Your ref: MA2024/0008
Our ref: 12547851

MA2024/0008 Bentley Quarry Modification - Response to Submissions

We provide the following in response to the letter from Richmond Valley Council (Council) dated 9 July 2024 requesting a response to the submissions in relation to MA2024/0008 Bentley Quarry Modification.

Figure 1 Bus routes

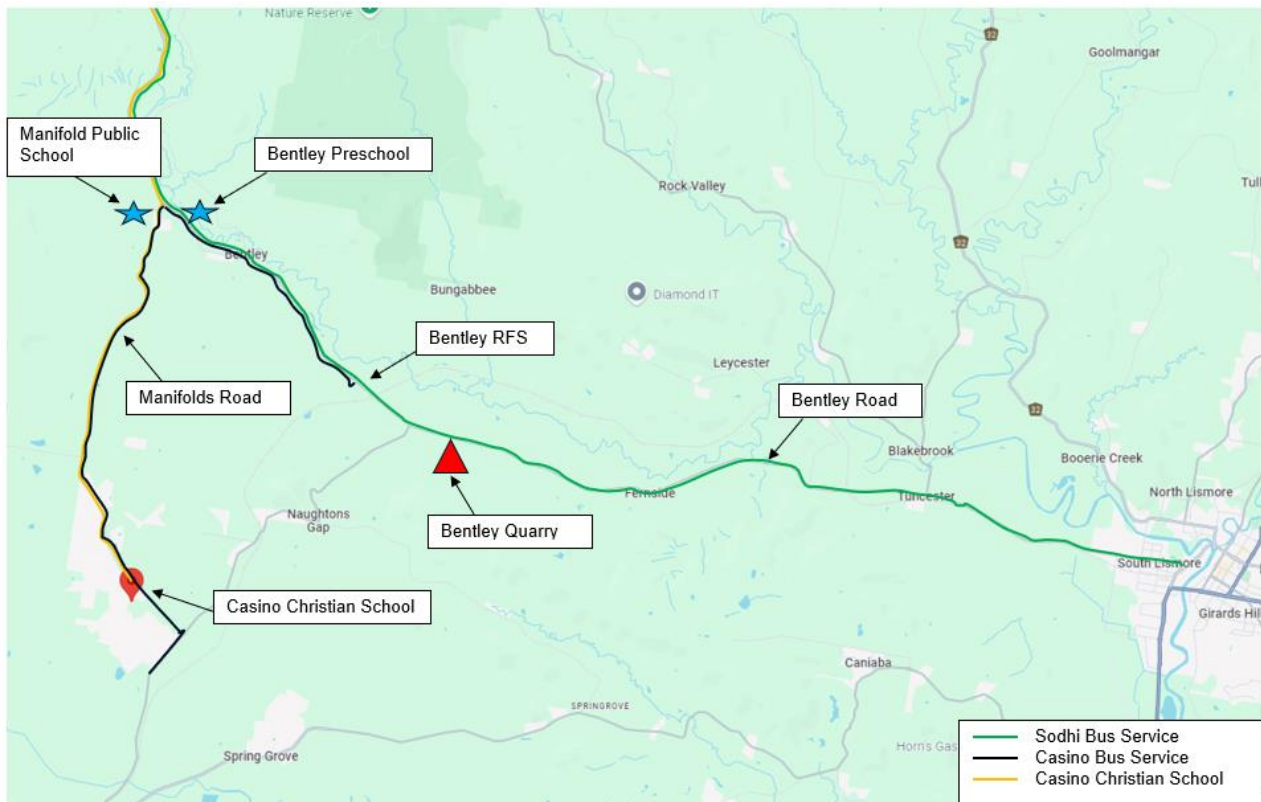
A briefing meeting was also held with the Northern Regional Planning Panel (the Panel) on 21 August 2024. At the meeting the Panel were interested in the actual schedule of school buses on Bentley Road and the impacts Condition 60(b)(ii) is having on Bentley Quarry operations.

Three school bus runs operate on Bentley Road but only Sodhi Bus Service travel past Bentley Quarry. A summary of the bus service and times near Bentley Quarry are provided in Table 1 and the routes are shown on Figure 1. Table 1 and Figure 1 were developed in consultation with each bus service provider and allows for minor delays.

As indicated, only Sodhi Bus Service travels past Bentley Quarry. Casino Bus Service meets the Sodhi Bus Service at the Bentley RFS shed and travels west. The Casino Christian School Bus Service travels on Bentley Road later in the morning and earlier in the afternoon than the Sodhi and Casino Bus Service, but only travel on Bentley Road between Manifolds Road and Kyogle.

Bentley Quarry rarely has trucks or clients to the west, so the potential for interaction between school buses and quarry trucks is mainly with Sodhi Bus Service between:
